FINAL
KENETECH/PacifiCorp
Windpower Project
Environmental Impact Statement

FINAL ENVIRONMENTAL IMPACT STATEMENT
KENETECH/PACIFICORP WINDPOWER PROJECT
CARBON COUNTY, WYOMING

FINAL ENVIRONMENTAL IMPACT STATEMENT FOR THE KENETECH/PACIFICORP WINDPOWER PROJECT CARBON COUNTY, WYOMING

Figure 2.1 Flow Chart Showing Environmental Review Process and Agency and Public Consultation.

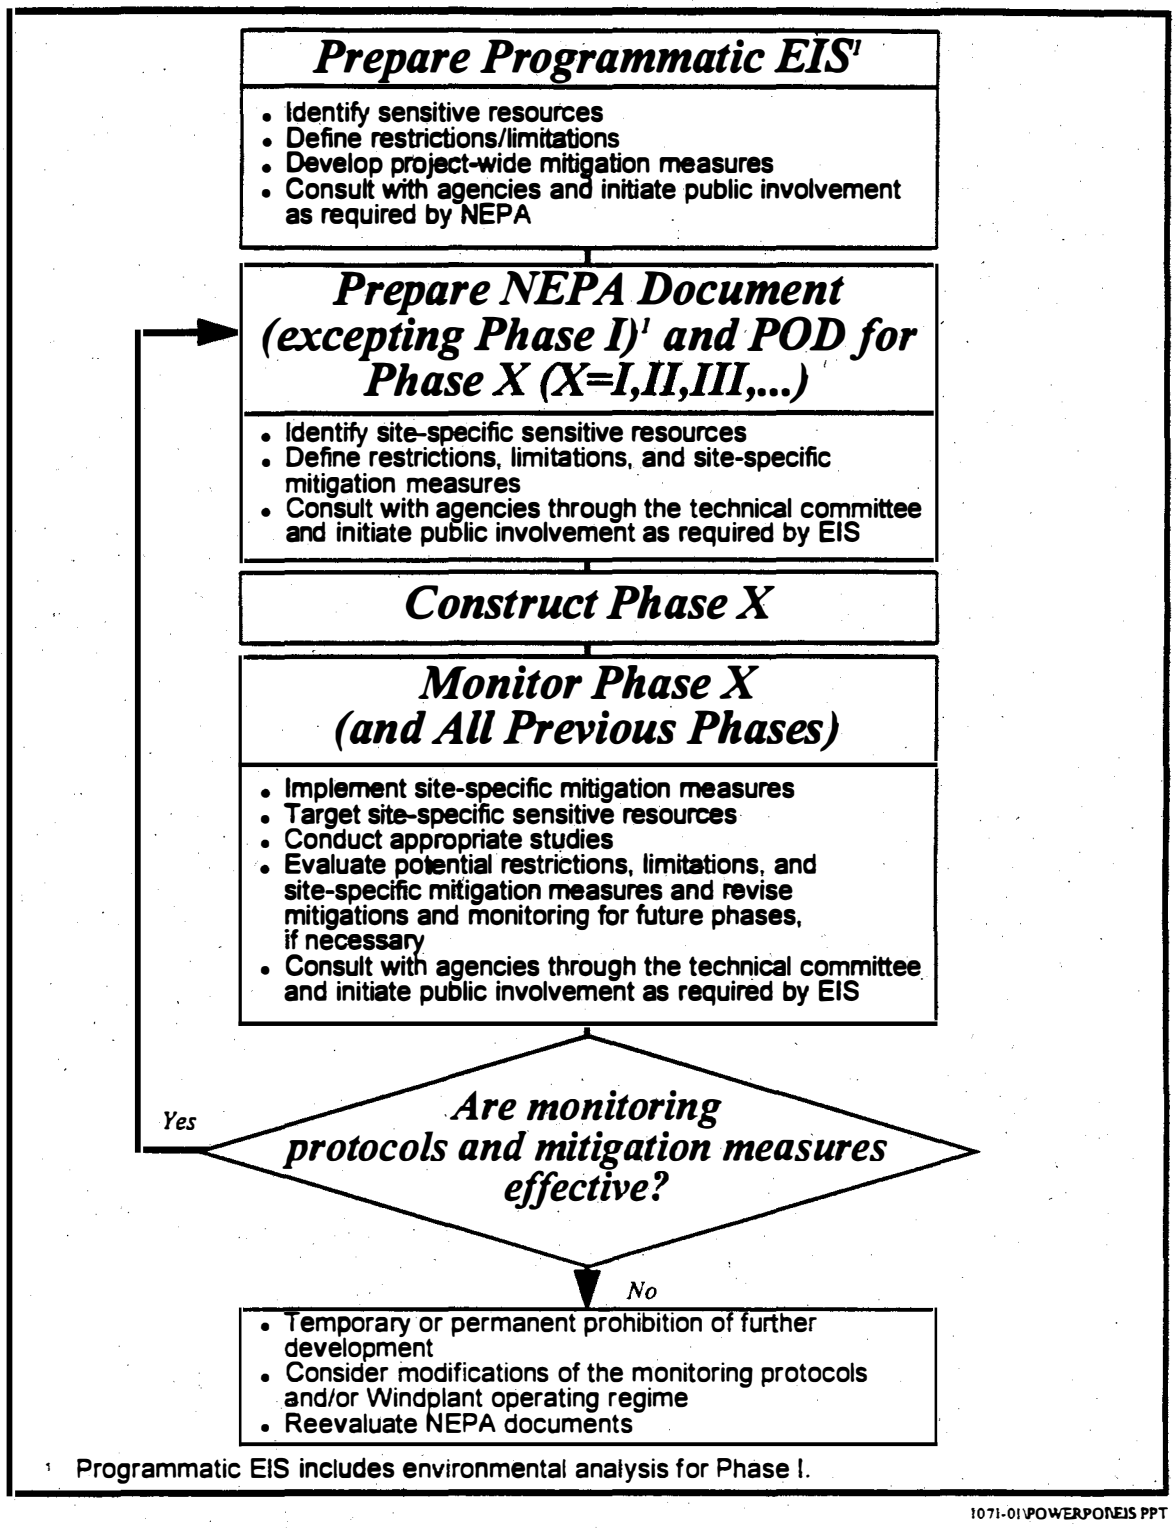
Page 2-7, Figure 2.1. Any additional mitigation measures that might be required in PODs should be included as contingencies in the EIS along with meaningful criteria for monitoring effectiveness. Such criteria have not been provided for in the DEIS.

Page 2-7, Figure 2.1. Replace Figure 2.1 in the DEIS with Figure 2.1 in the FEIS.

Figure 3.2 Mean Number of Raptor Observations and Mean Number of Raptor Species Observed during Raptor Use (Continuous) and Passerine Surveys.

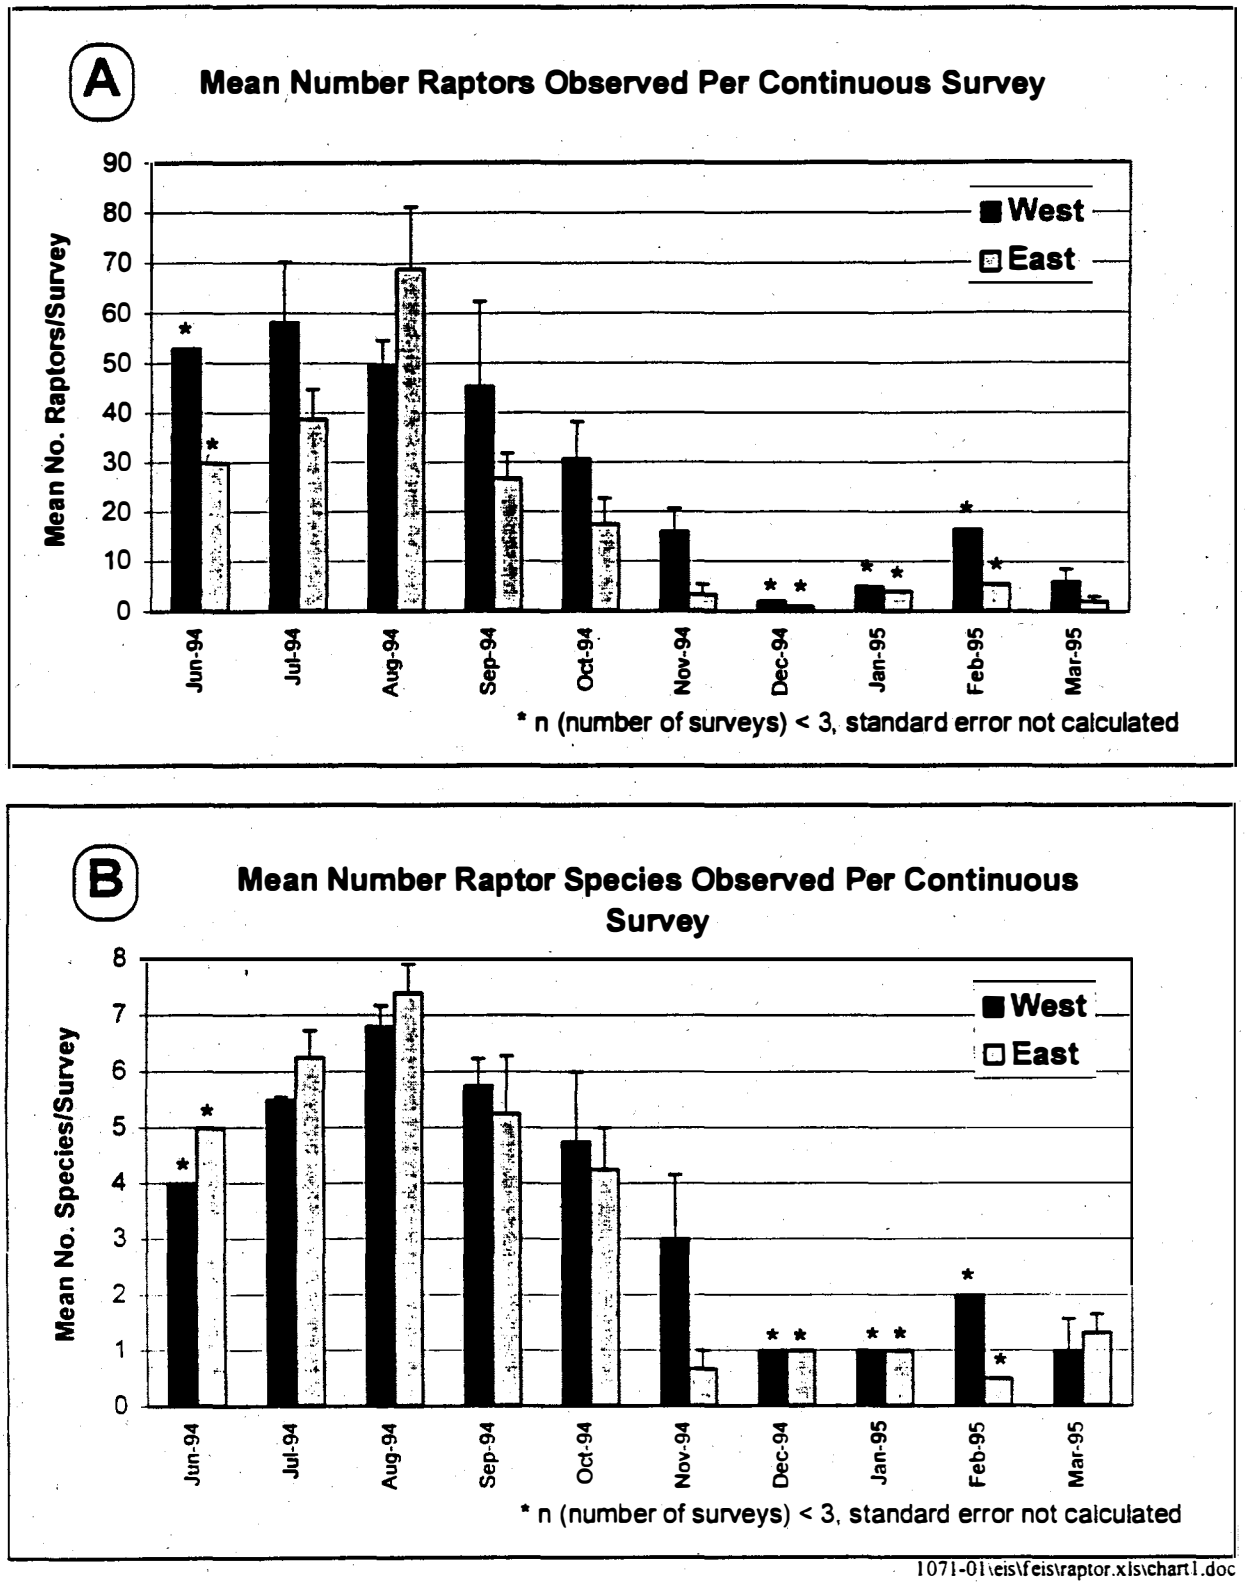
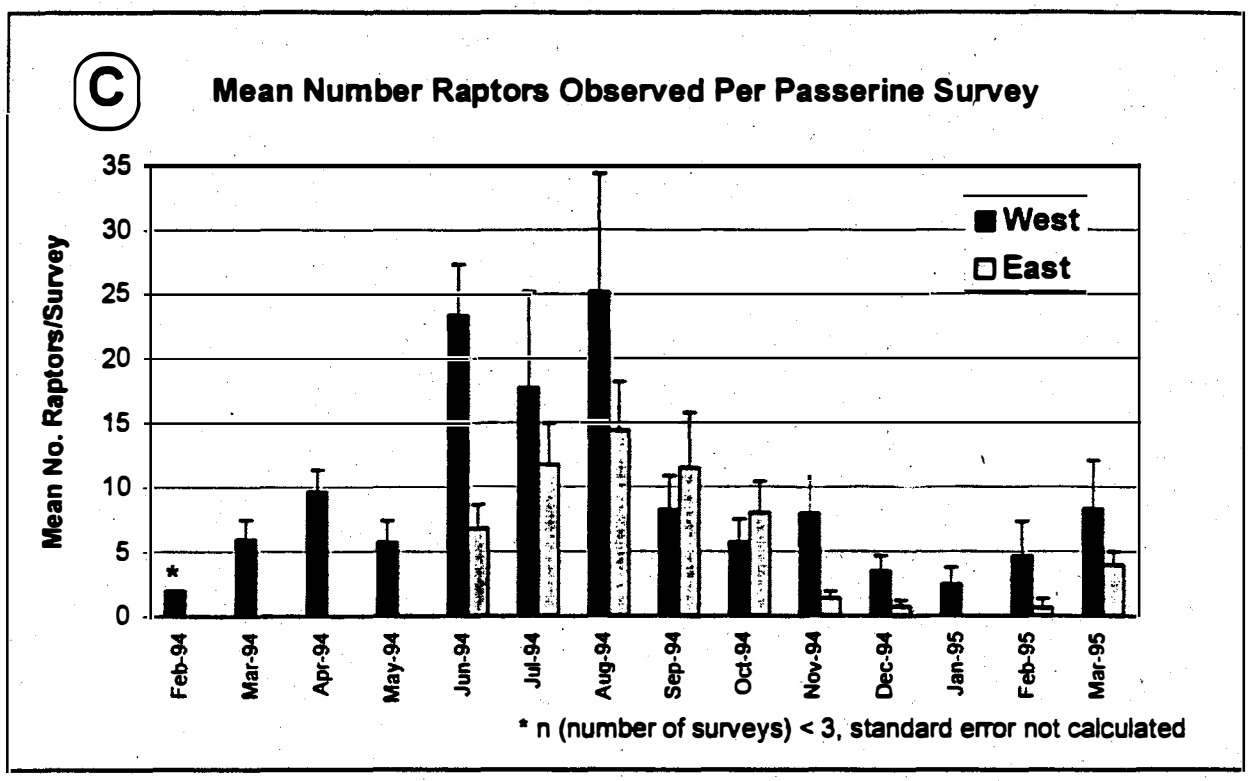
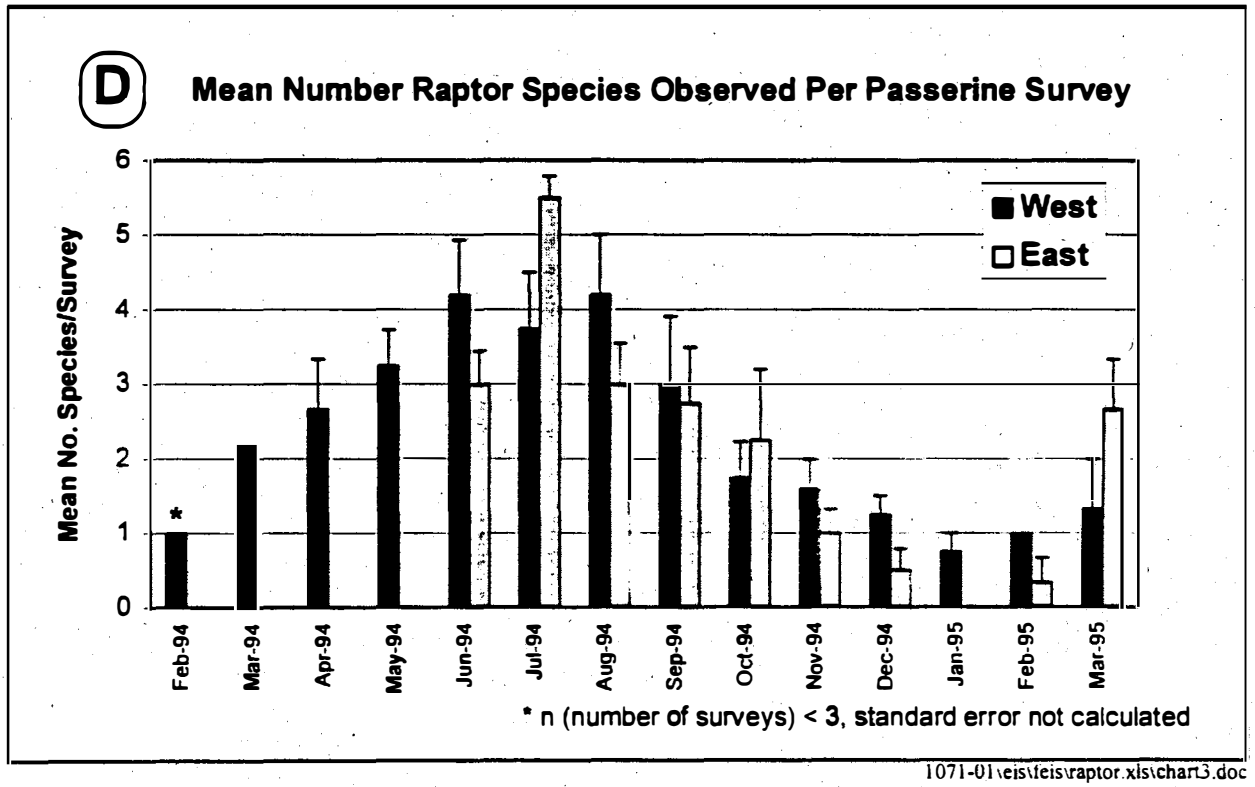
74 51) RE: Reliability of Raptor Seasonal Use Data (p 3-48, Fig 3.2) -- This figure should include confidence intervals about the mean number observed per monthly survey.

93 Page 3-48, Figure 3.2 It would be more meaningful if this figure included confidence intervals about the mean number observed per monthly survey to help assess reliability of the data

Comment AE74: Standard errors have been calculated and error bars have been added to the appropriate figures. Figures 3.2A and 3.2B in the DEIS were based on the total number of raptor species observed per month divided by the number of survey days for that month. These numbers have been recalculated by averaging the total number of species per survey by month to give a more representative overview of the data. This eliminates the tendency to underrepresent species which were commonly observed (i.e., golden eagle). See Figures 3.2 (A-D) and 3.3 (A-B) in Section 3.2 of the FEIS.

Comment AP93: Standard errors have been calculated and error bars have been added to the figures. Figures 3.2A and 3.2B in the DEIS were based on the total number of raptor species observed per month divided by the number of survey days for that month. These numbers have been recalculated by averaging the total number of species per survey by month to give a more representative overview of the data. This eliminates the tendency to underrepresent species which were commonly observed (i.e., golden eagle).

Figure 3.3 The (A) Mean Number of Passerine Species Observed Per Survey and (B) Mean Number of Passerine Observations Per Survey Along the West and East Sides of Foote Creek Rim, May 1994 to March 1995.

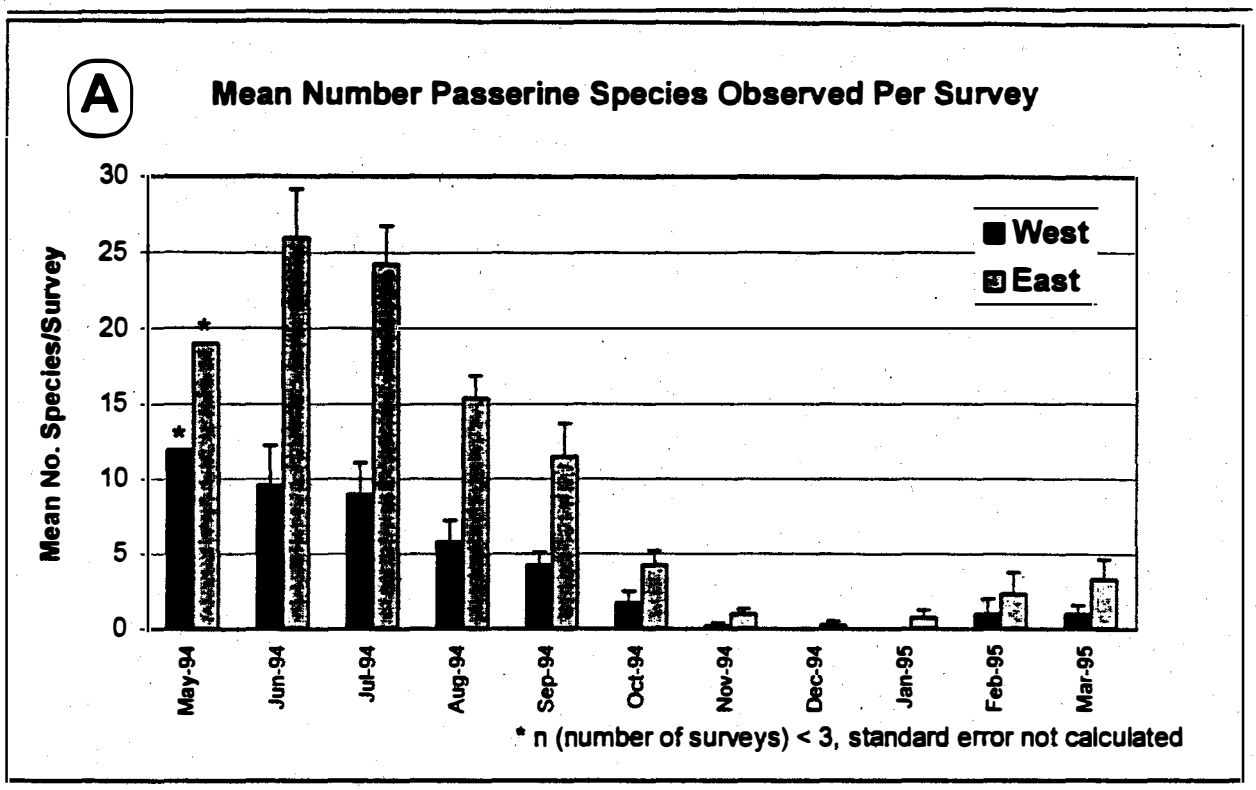
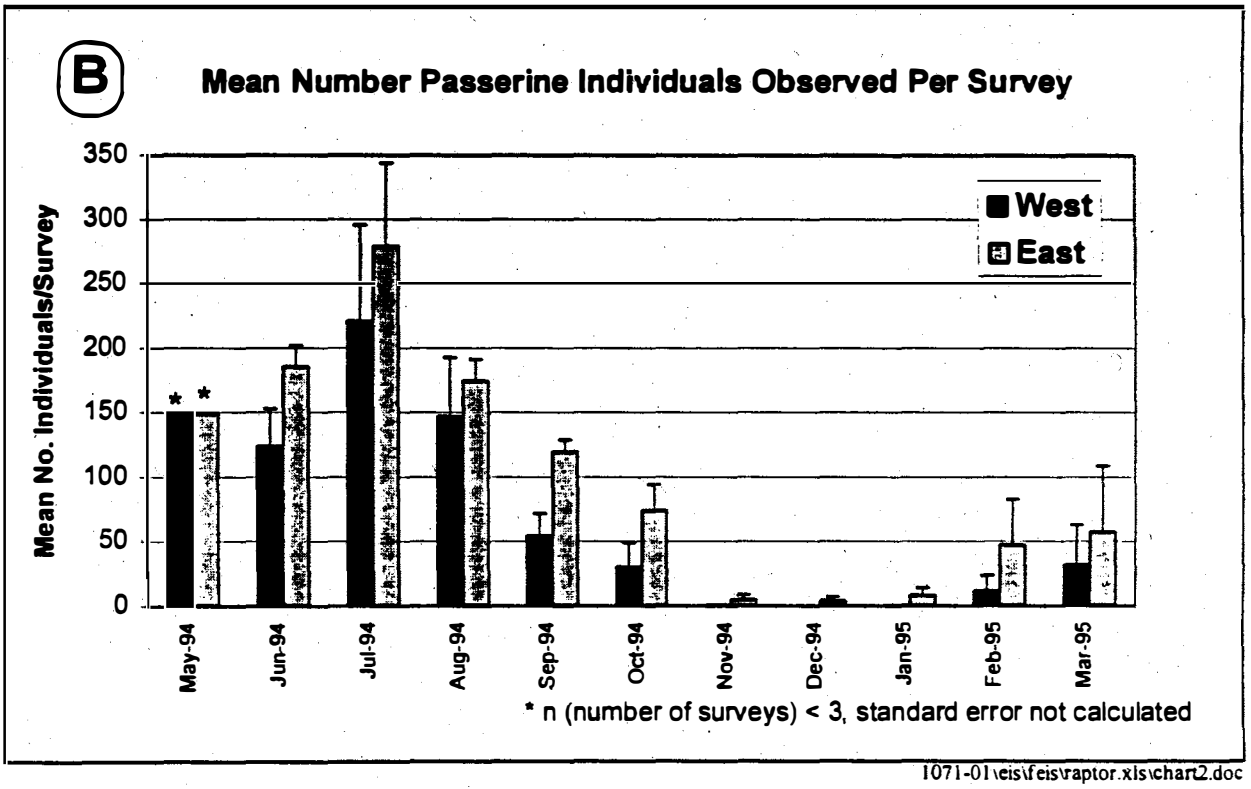
98 Page 3-61, Figure 3.3: Again, confidence intervals should be provided with the means on these figures to help readers assess the quality of the data presented

Comment AE85: Standard errors have been calculated and error bars have been added to Figure 3.3 in the DEIS. Figure 3.3A in the DEIS (Section 3.2.2) was based on the total number of passerine species observed per month divided by the number of survey days for that month. These numbers have been recalculated by averaging the total number of species per survey by month to give a more representative overview of the data. This eliminates the tendency to underrepresent species which were commonly observed (i.e., horned lark). See Figure 3.3 (A-B) in Section 3.2 of the FEIS.

Comment AP98: Standard errors have been calculated and error bars have been added to Figure 3.3 in the DEIS. Figure 3.3A in the DEIS was based on the total number of passerine species observed per month divided by the number of survey days for that month. These numbers have been recalculated by averaging the total number of species per survey by month to give a more representative overview of the data. This eliminates the tendency to underrepresent species which were commonly observed (i.e., horned lark).
